26-OVERLAY-0004

Mid City Market

**Bardstown Rd/Baxter Ave Corridor Review
Overlay District Committee**

April 21, 2026

PEDESTRIAN CONNECTIVITY

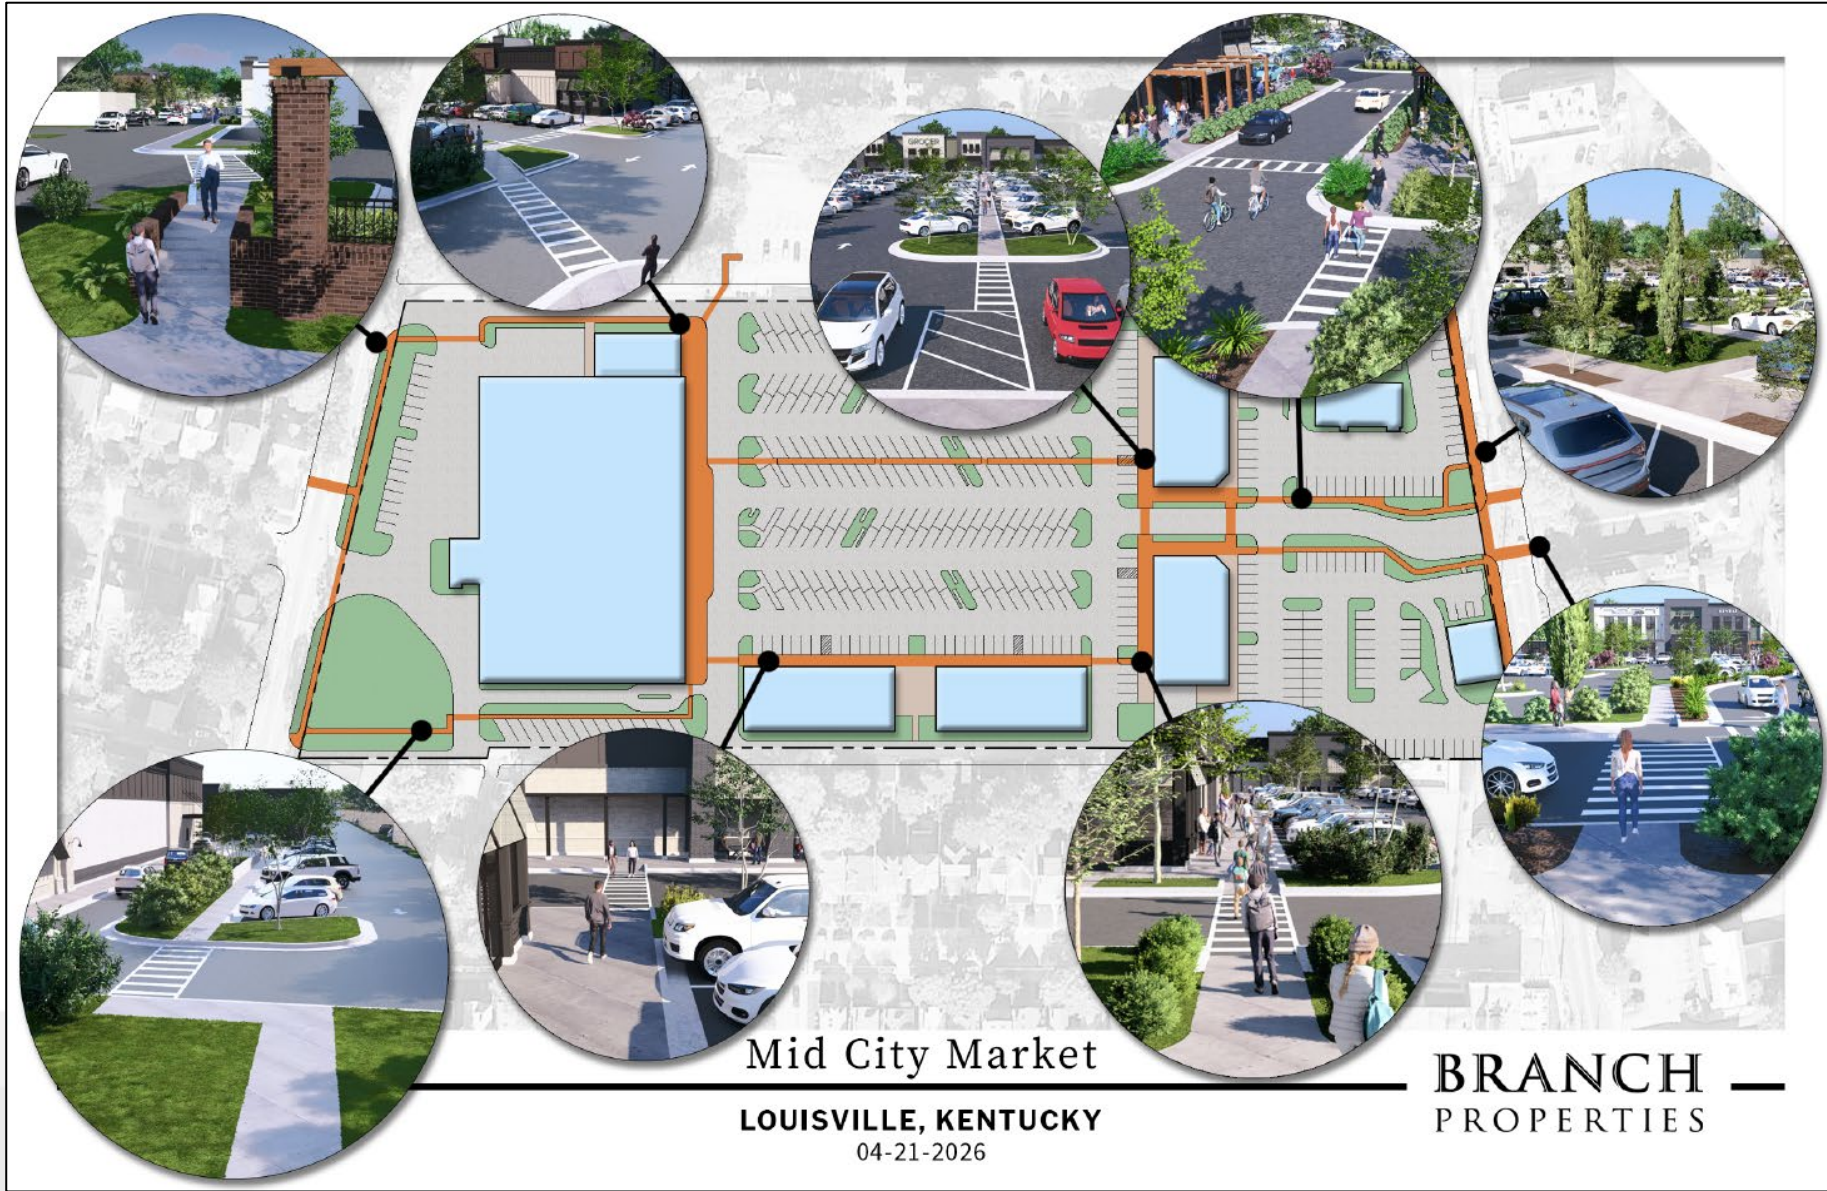
- At the March 17, 2026 meeting, the BROD Committee continued the case and requested the applicant consider three areas for revision:
 1. Pedestrian connectivity across the site;
 2. Treatment of the Baxter Avenue façade; and
 3. Inclusion of red brick within the development.

All pedestrian walkways and crosswalks throughout the site
